County of Hawaii  
PLANNING DEPARTMENT

April 5, 2007

**Ohana Dwelling Unit Permit Application (OHD-07-000094)**  
**Applicant(s): Ronald Nahakuelua**  
**Land Owner(s): Ronald Nahakuelua**  
**Proposal: Construct A Detached Ohana Dwelling Unit**  
**Tax Map Key: (3) 2-5-053:003**

PLOT PLAN - 3/8" = 1'-0"  
TAX MAP KEY: 2-5-053: 903  
LOT: 110

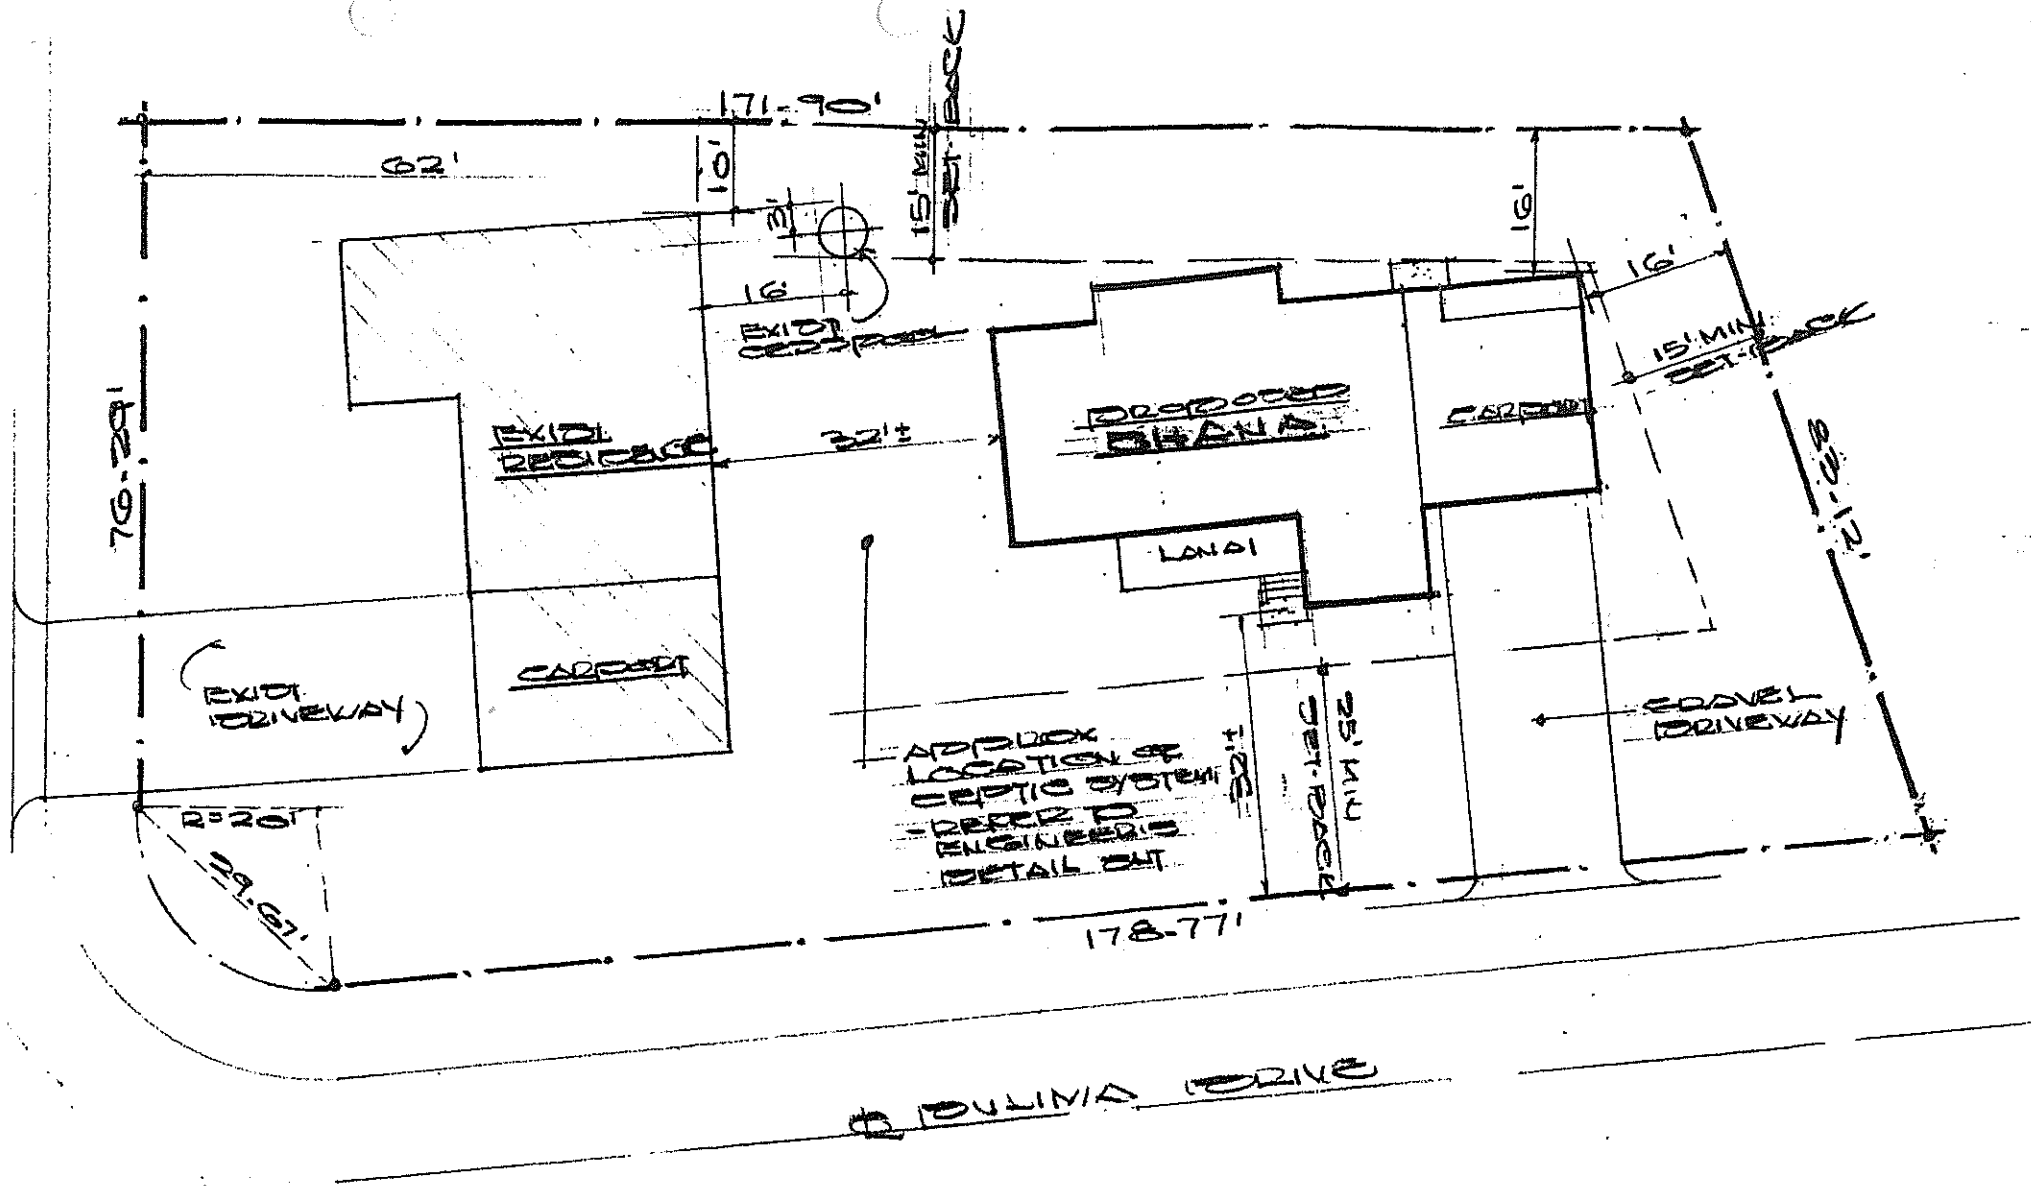
1. Driveway access from Pulima Drive to the proposed ohana dwelling unit shall comply with Chapter 22, County Streets, of the Hawaii County Code (HCC). Proper driveway approach shall be provided as required by HCC, Section 22-4.8 and in conformance with DPW Standard Details R-37 and R-38.

Please be informed that the subject parcel is currently served by a 5/8-inch meter, which is adequate for only one dwelling at an average daily use of 400 gallons. Inasmuch as this application is proposing an additional dwelling, the installation of a separate 5/8-inch meter will be required. Water can be made available from the Department's existing 8-inch waterline within Pulima Drive, fronting the subject parcel.

This lot is allowed only one sewage disposal system (10,000 sq.ft. per septic system). Two disposal systems require a minimum of 20,000 sq.ft. lot size. A septic system can serve a maximum of 5 bedrooms. Unless the number of bedroom for the two dwellings is 5 bedrooms or less, the Health Department does not concur with the ohana dwelling."

- Front yards - minimum **twenty five** (25) feet required;
  - Rear yard – not applicable, corner lot;
  - Side yards – minimum **fifteen** (15) feet required;

- Open space from other main structure(s) – minimum **fifteen** (15) feet required.
- d) Off-Street Parking: The Ohana Dwelling Unit shall be provided with a minimum of two (2) off-street parking spaces that comply with the requirements of Section 25-4-53 of the Zoning Code. All existing and additional parking spaces shall be arranged so as to be individually accessible.

7. We note the DOH comment that the total number of bedrooms allowed in the two dwellings shall be limited to five and that they both must be serviced by a single septic system.
